Center for Health Protection, Drinking Water Services

Re: Buell-Red Prairie Water District (PWS ID# <u>01174</u>) Membrane Module Replacement with 12 Toray HFUG-2020AN Modules Final Approval – PR# <u>27-2024</u>

Final Approval PR #27-2024 – Membrane Module Replacement w/ 12 Toray HFUG-2020AN Modules September 11, 2024

SCADA Screens and PLC Programming from 4/24/24

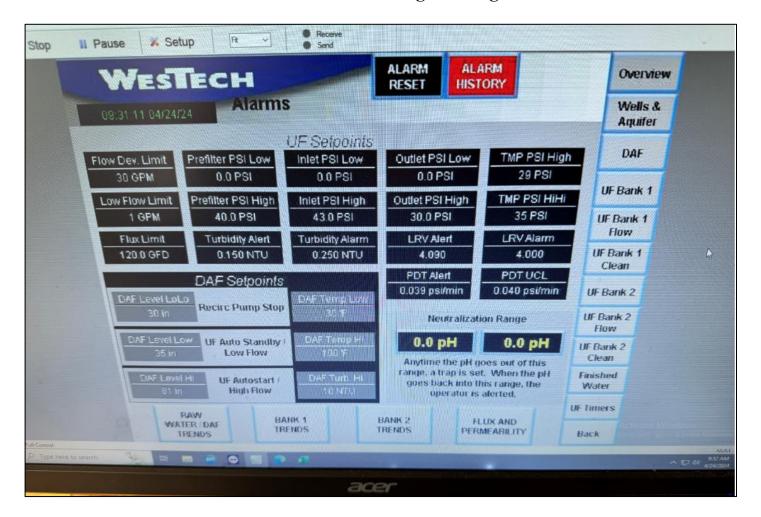
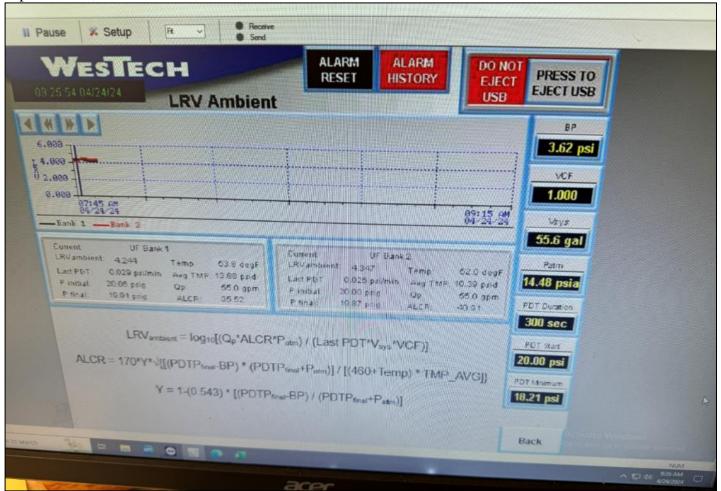
- The TMP PSI HiHi alarm is set to 35 psi and should be 29 psi or less and the backpressure (BP) is set to 3.62 psi rather than 3.64 psi WesTech specified.
- The backpressure was revised to 3.64 psi, however the revision was not known until after the programming work was already completed by TAG.

- Although these changes have a negligible effect on $LRV_{ambient}$ and the direct integrity test pressure, these values should be updated with any future programming changes.
- WesTech should be consulted to see if the TMP PSI HiHi alarm should be revised sooner and to what value (less than 29 psi).

³ PLC programming is using 3.62 psi, which yields a minimum DIT test pressure of 18.21 psi.

⁴ PLC programming is using the UCL of $\underline{20 \text{ psi}}$ for P_{test} in the ΔP_{eff} equation, which will yield a lower and more conservative ALCR and lower LRV_{ambient}.
